Summary of Items Discussed in 4/2021 APSEC Discussion Forum on 13 August 2021

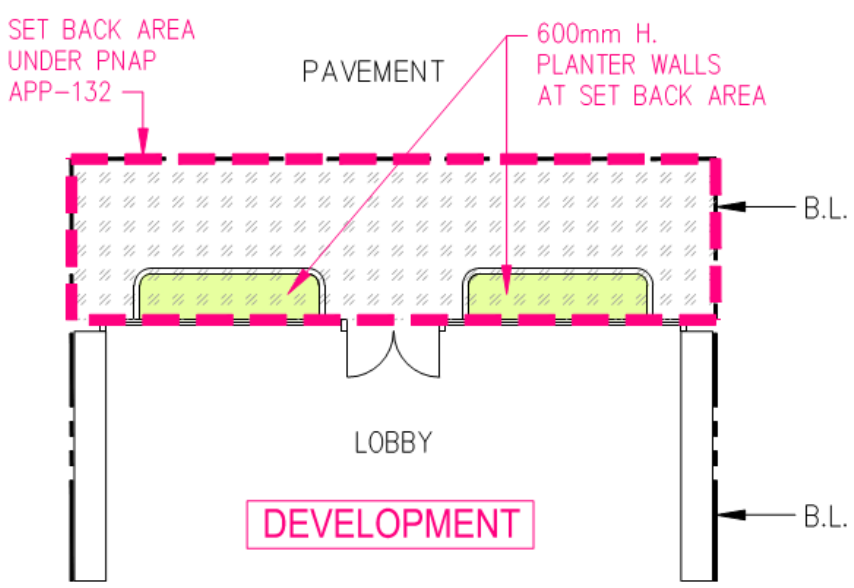
8.	<p><u>Fragmentation Test of Tempered Glass</u></p> <p>According to Clause 8.1.2 of CoP for Structural Use of Glass 2018, Fragmentation Test of tempered glass should be carried out in accordance with Section 10 of BS EN 14179-1 after the heat soak process. Would BD please confirm if the method of particle count shall be strictly in accordance with Annex C of BS EN 14179-1 (extracted copy attached).</p> <div data-bbox="250 1131 315 1193" data-label="Image"> </div> <p>BS EN 14179-1 2016 - Extracted S</p>	BD advised that fragmentation test of tempered glass should be carried out in accordance with Section 10 of BS EN 14179-1 with examples given in Annex C therein to illustrate the test procedures.
